**Subject: Official Plan Amendment and Zoning By-law Amendment – 400
Coventry Road**

File Number: ACS2025-PDB-PS-0050

Report to Planning and Housing Committee on 20 August 2025

Figure 1 – existing dwelling unit totals compared to the 1,768 units proposed at 400 Coventry Road

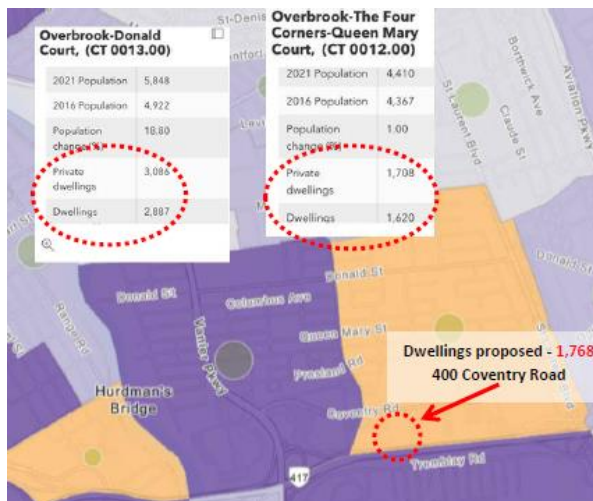
And it is a community that is being built at 400 Coventry Road not just some buildings. Compare the dwelling unit total and population sizes with existing Overbrook (Figure 1), which we had presented in our January comments. The dwelling unit total at 400 Coventry Road would be equivalent to a large part of existing Overbrook. The above table indicates a new population increase of 5,070 persons.

Figure 3 – project development evolution

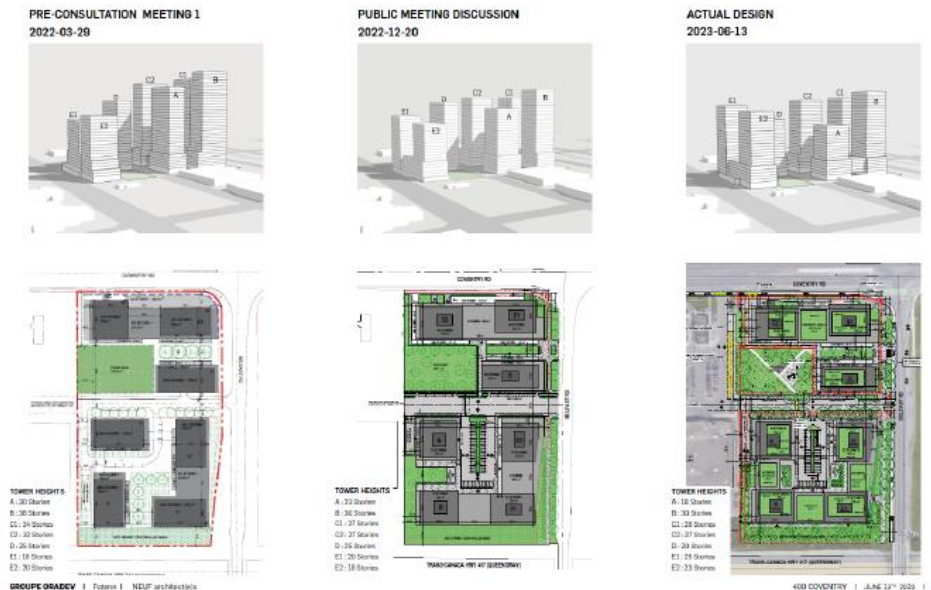
Shade on the park – The evolution of this site plan has seen the height of Building A, directly to the south of the park, known as “the shadow maker”, decrease in proposed height from 30 storeys to 23 storeys to 18 storeys (Figure 3 below). This is appreciated and it will to a degree lessen the shadow impacts as seen in the four season scenarios of the sun study with the illustrations of impact of shadows at various times of the day.

Figure 5 – Excerpt of the new Active Transport Network

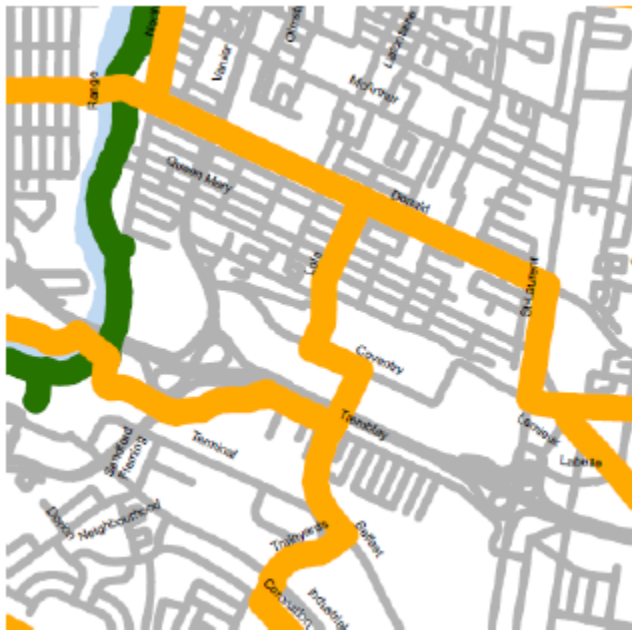
The Planning and Design Brief (page 12) shows the old City cycling network with only Coventry Road as part of that network in front of this site. The new Transportation Master Plan and Active Transportation have both frontages of Coventry and Belfast Roads as being on the new cross town cycling network (Figure 5 – previous page). 400 Coventry Road is ideally located to take advantage of this route be it to go to transit
